# Product Change Notification

## 112960 - 00

**Change Notification #:** 112960 - 00  
**Change Title:** Intel® Server System P4308IP4LHJC  
PCN 112960-00, Product Design  
Power Distribution Board Cable Change  
**Date of Publication:** March 31, 2014

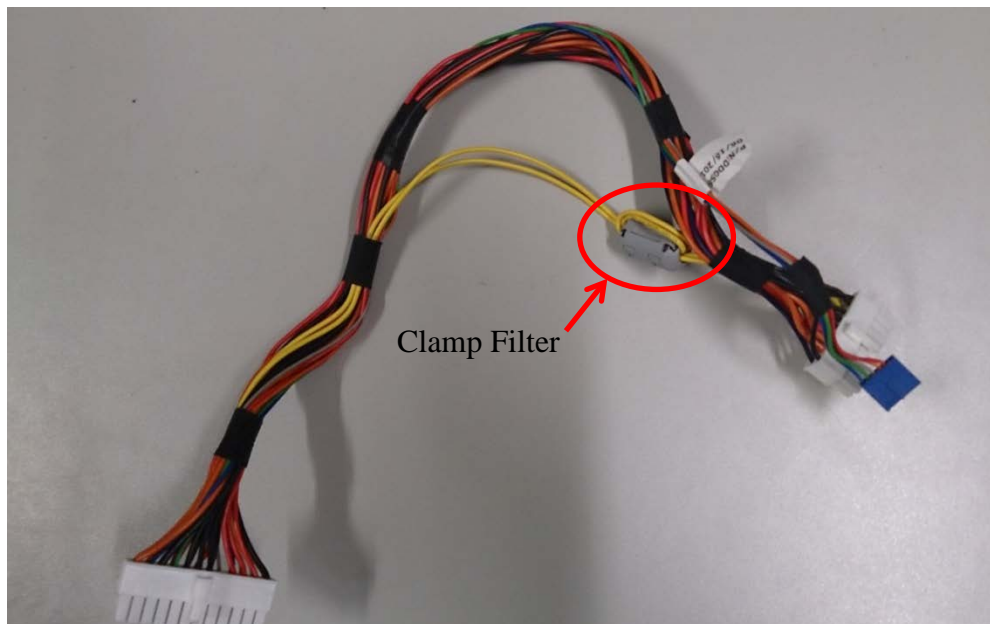
Intel is implementing the following change on the Intel® Server System P4308IP4LHJC that is configured with the power supply redundancy function:

1. Install a clamp filter onto the power distribution board cable. Please refer to the following figure and see TA1047-1 for more details.
